Access Compliance Report

Public Rights-of-Way

(Curb Ramps)

Intersection ID: 27388	Main Street: CONLAN_CR	Cross Street: BRIXHAM_HILL_AV	Location: SE
ADA ID: 91A3AE9F6DB7	Ramp Type: Perp	Initial Pass/Fail: Fail	Overall Compliance: No
Severity Score: 8.75			
Codes/Mitigation Info/Possible Solution		Field Measurements/Component Compliance

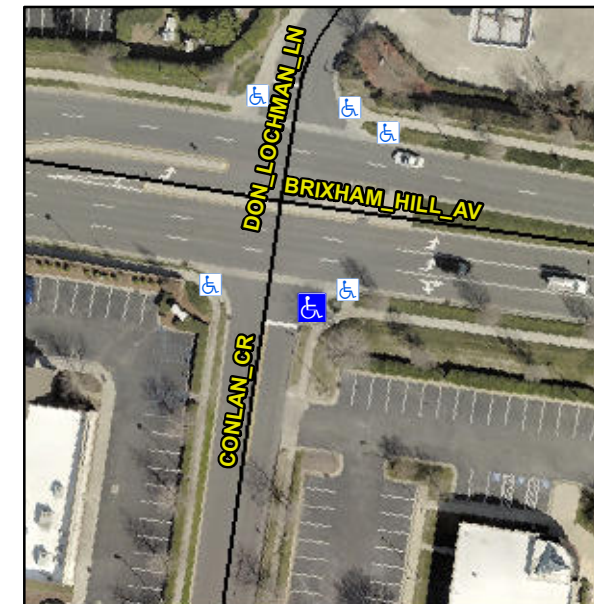
R304.5.1

Compliance	Description	Data	Compliance	Description	Data
N/A	Ramp Length (in)	68.0	Yes	Ramp Slope (%)	7.5
No	Ramp Width (in)	47.0	Yes	Ramp XSlope (%)	1.6
N/A	Flare Type LT	N/A	N/A	Flare Type RT	N/A
N/A	Flare Slope LT (%)	N/A	N/A	Flare Slope RT (%)	N/A
N/A	Flare Traversable LT?	N/A	N/A	Flare Traversable RT?	N/A
N/A	Landing Length (in)	N/A	N/A	DWS Provided?	N/A
N/A	Landing Width (in)	N/A	N/A	DWS Contrast?	N/A
N/A	Landing Slope (%)	N/A	N/A	DWS Length (in)	N/A
N/A	Landing X Slope (%)	N/A	N/A	DWS Full Width?	N/A
N/A	Landing Curb? (Y/N)	N/A	N/A	DWS Offset (in)	N/A
N/A	Shared Landing?	N/A			
N/A	Gutter Ponding?	N/A	N/A	Gutter Slope (%)	N/A
N/A	Gutter Lip Ht (in)	N/A	N/A	Gutter X Slope (%)	N/A
N/A	Painted X Walk1?	No	N/A	Painted X Walk2?	N/A
	X Walk 1 Direction	To W		X Walk 2 Direction	N/A
N/A	X Walk 1 Width (in)	N/A	N/A	X Walk 2 Width (in)	N/A
	X Walk 1 Slope (%)	3.7		X Walk 2 Slope (%)	N/A
	X Walk 1 X Slope (%)	2.1		X Walk 2 X Slope (%)	N/A

Remove & Replace Entire Ramp.
